CHAPTER 3 TRANSPORTATION

Changes to the Draft EIS/EIR

As a result of the foregoing, several text changes to the Draft EIS/EIR are needed to reflect the above changes to the Hybrid Alternative/SRA introduced in this Final EIR and to make minor text revisions in response to comments and/or to correct minor typographical errors.

Figure 3.3-10 2020 and 2035 Daily Transit Ridership

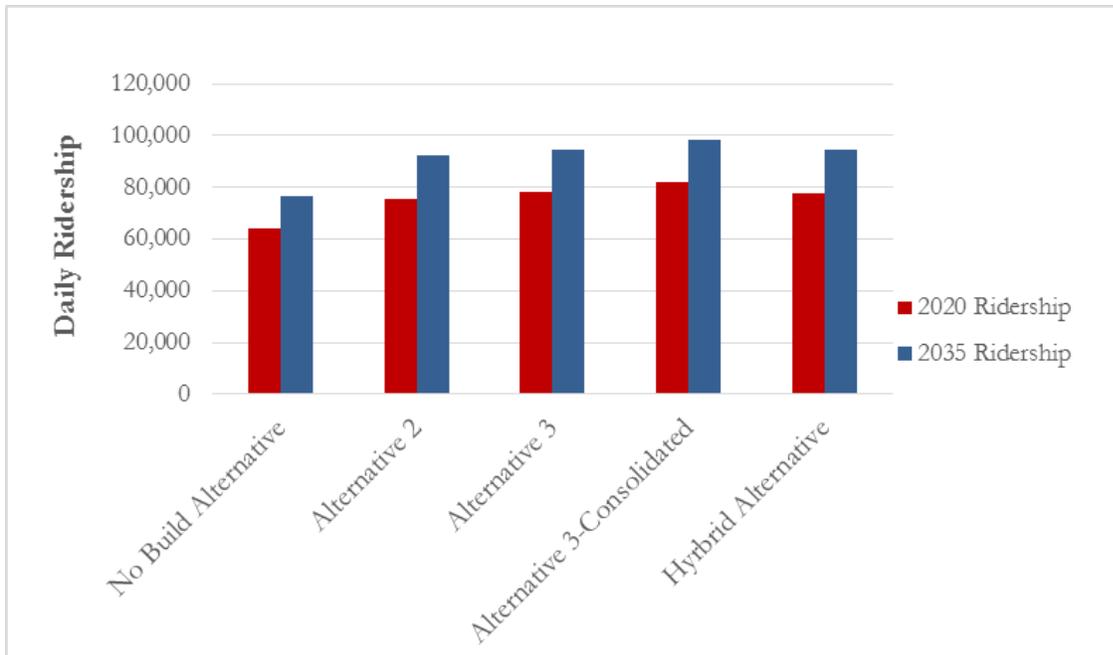
Page 3.3-18, text and figure edits (Figure 3.3-10) to correct minor typographical errors

³ The only change to Figure 3.3-10 from the Draft EIS/EIR is to the No Build Alternative ridership number bars, thus this change is not shown in the strikethrough underline format.

Projections of future Geary corridor bus ridership show that weekday Geary corridor boardings would increase by approximately ~~29~~21 percent from over 50,000 in 2012 to about ~~70,000~~64,000 in the year 2020. Ridership is projected to increase by an additional ~~24~~19 percent to ~~nearly 84,000~~ about 77,000 in 2035 under the No Build Alternative; this ridership increase is related directly to the expected increases in study area population. The No Build and build alternatives would result in higher ridership on Geary corridor bus routes.

In 2020, the build alternatives would result in daily transit boardings ~~ranging between 75,000 and 82,000 boardings (9 percent to 18 percent higher than in the No Build Alternative)~~ of up to 82,000 boardings (28 percent higher than in the No Build Alternative). In 2035, the build alternatives would serve between 92,000 and 99,000 daily transit riders (~~44~~20 percent to ~~48~~28 percent higher than in the No Build Alternative).

Figure 3.3-11 Year 2020 Geary Corridor Bus Travel Times (Entire Corridor, 48th Avenue to Transbay Terminal)

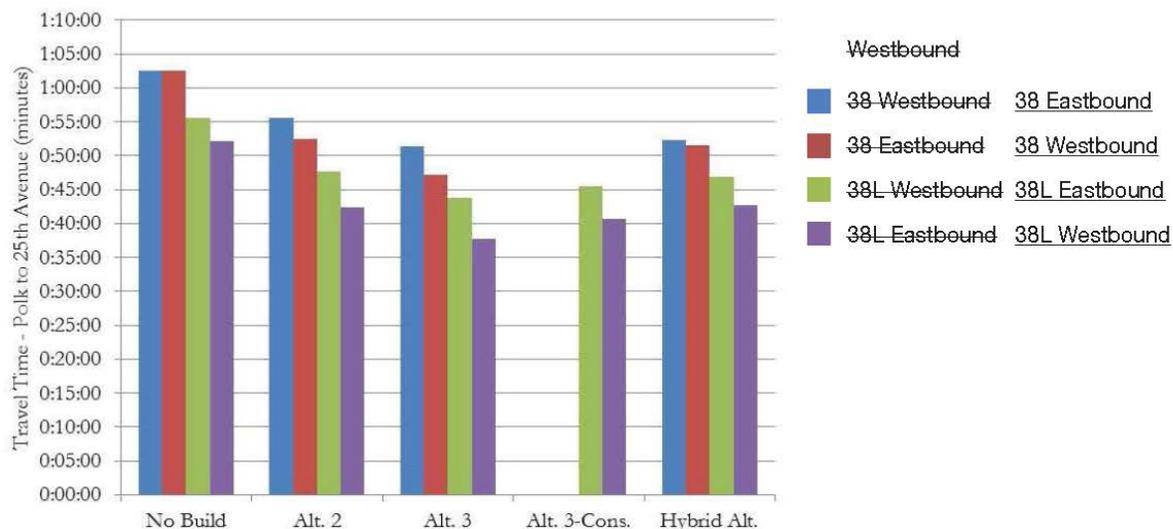
Page 3.3-21 and 3.3-23, figure edits
